General comparison without data

Monochromatic powder C60 data

Now let us look at a particular dataset, IPTS-19573 / run-130257. C60, Ei=60meV

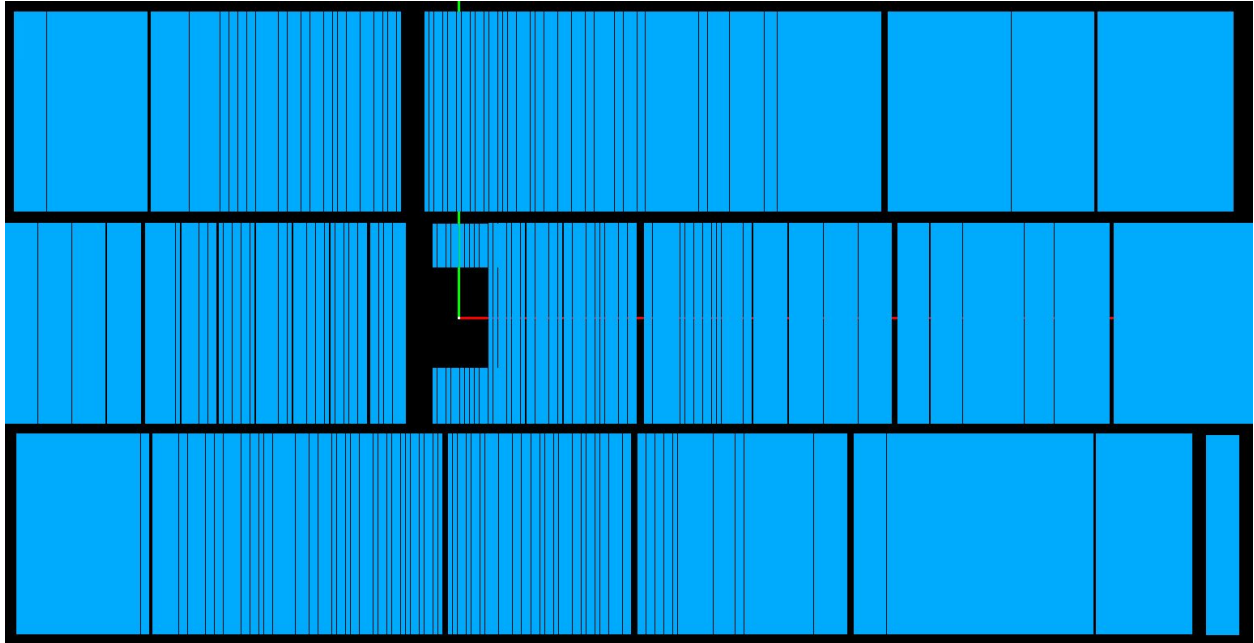
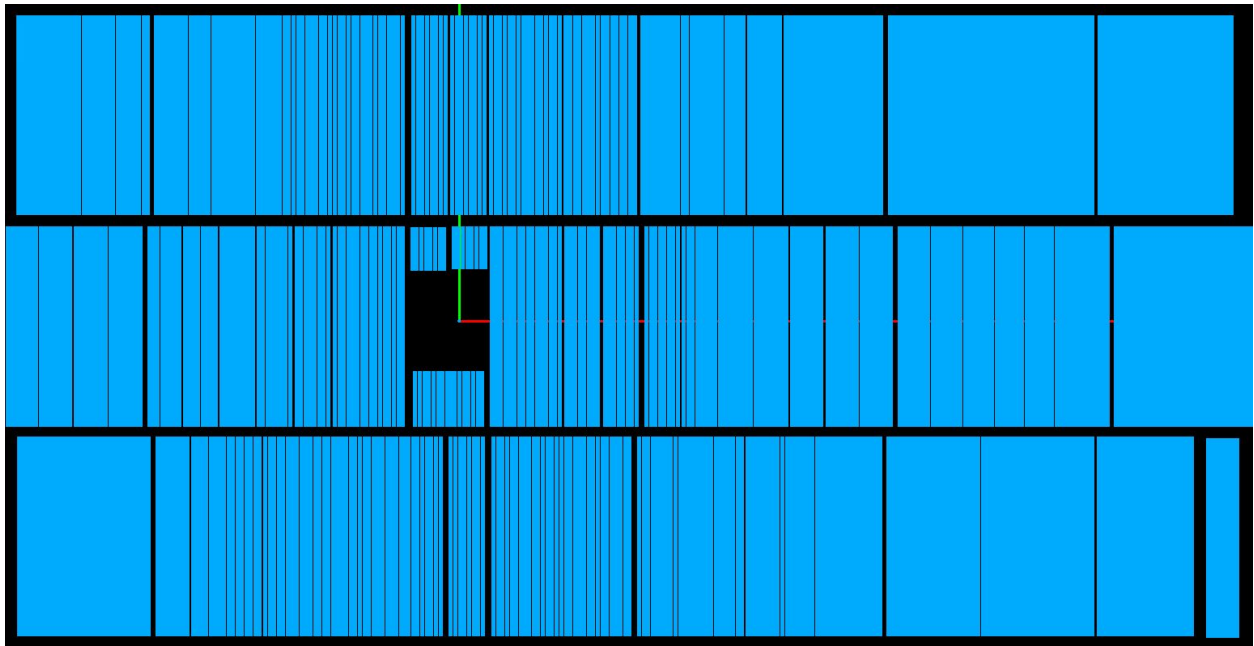
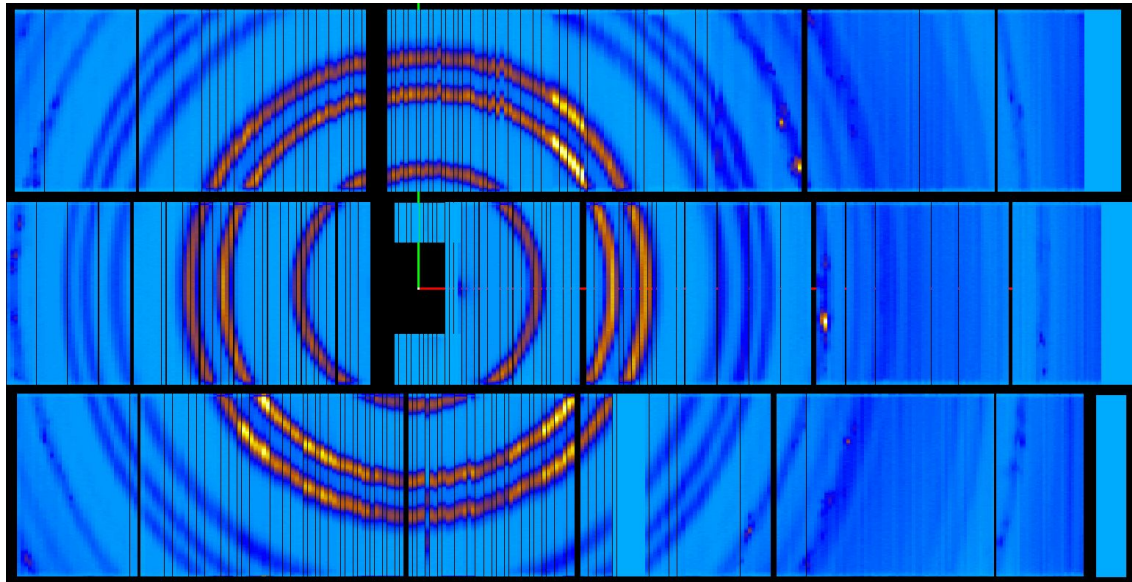
The calibration fixed a few things

- Two gaps for the top row: the second gap got narrower, the third gap shows up
- The short packs in the middle row

- The fourth gap in the bottom row

The main thing that is unsatisfactory is that the gap between B27 and B26 is missing. And the gap between B25 and B24 is probably too large.

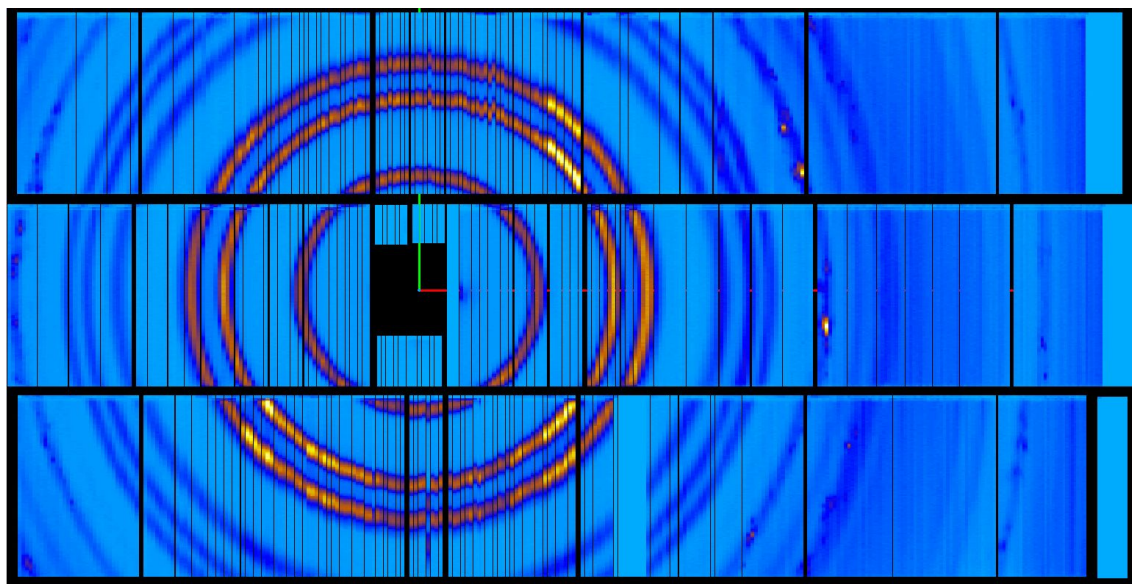
It is obvious that in the top-left portion of the view the rings are more rounded after calibration. A portion of a ring near the 4th gap in the bottom row is better too. These makes us confident that the calibration is doing well for most of the detector packs.

B28-B25

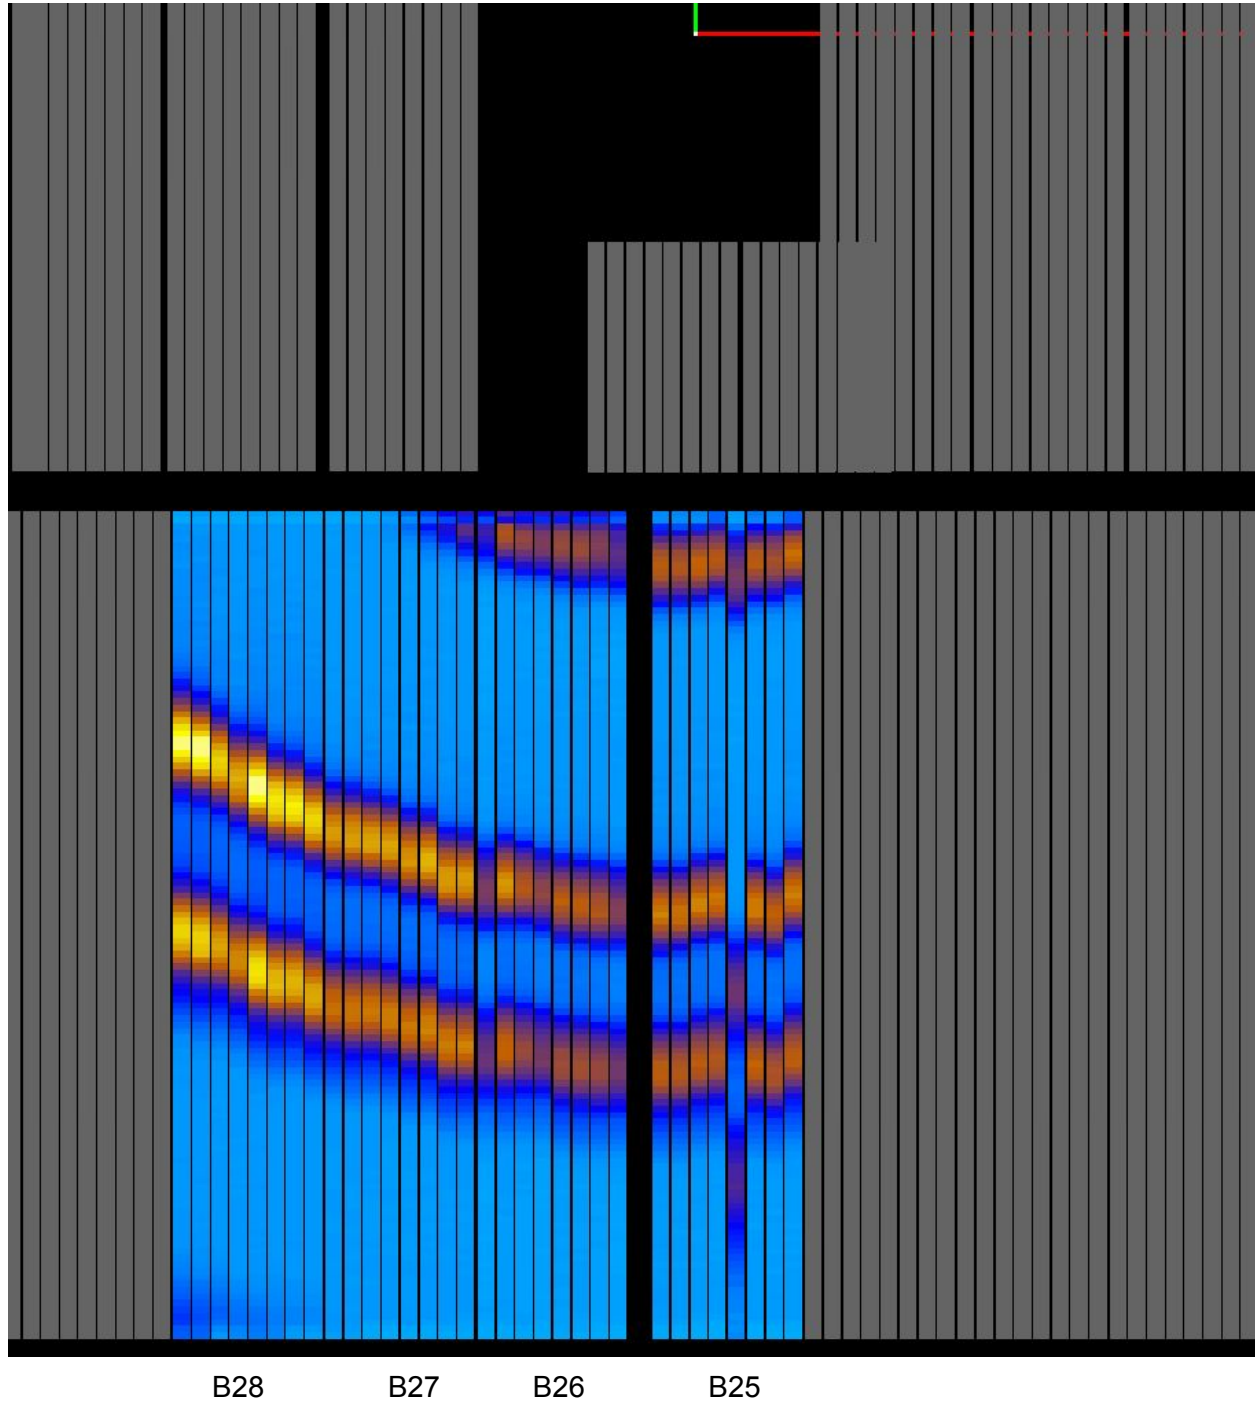
Clearly the rings in B25 (the right most pack) is not the best quality. The tube 4 is very much off. Tubes 5-8 show a consistent trend. Tubes 1-3 show the same trend as tube 5-8 at the top but not so much in the middle and lower part.

Now B26. Comparing to the trend in B28 and B27, the data in B26 (with the exception of tube 8) indicates that it should be either lower or more to the left. However, the gap we expect between B27 and B26 would require B26 to move to the right.

In summary, B25 and B26 need more inspection. **Is it possible that the electronic mapping of pixels is slightly off? This is most obvious at tube 4 of pack B25.**
